# 2001 - 2003 Corvette: Service Manual Update: Revised Wheel Drive Shaft Outer Joint and Seal Replacement and Wheel Drive Shaft Inner Joint and Seal Replacement Procedures

**Number:** 03-04-95-001 - (01/09/2003)

**Models:** 2001-2003 Chevrolet Corvette

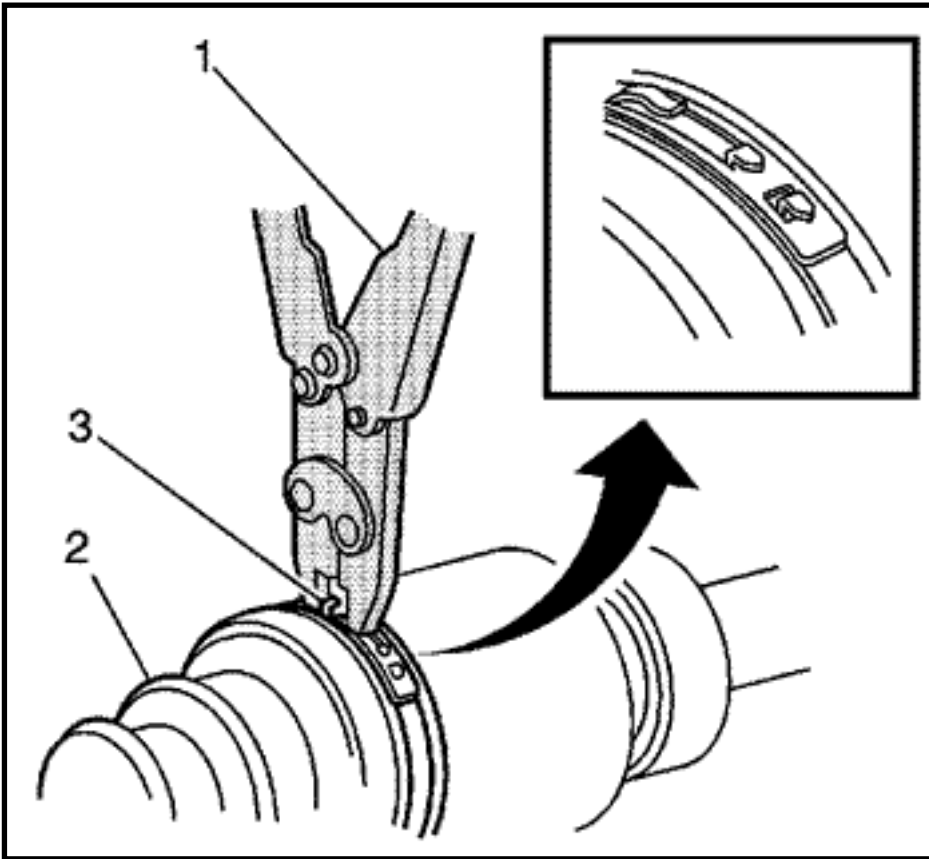
Because of a mid-year change in 2001, the large diameter clamp is now a low profile design, instead of the Omega clamp design. The new design clamp requires the use of Special Tool J 46588 to install. The following steps effect 2001 model year vehicles with the second design clamp and all 2002 and future model year vehicles.

Align the following items while latching:

- The wheel drive shaft inboard seal (2)
- The tripot housing
- The large seal retaining clamp (3)

Using the J 46588 (1), latch the large seal retaining clamp. Ensure that the latching tangs are fully engaged in the large seal clamp band.
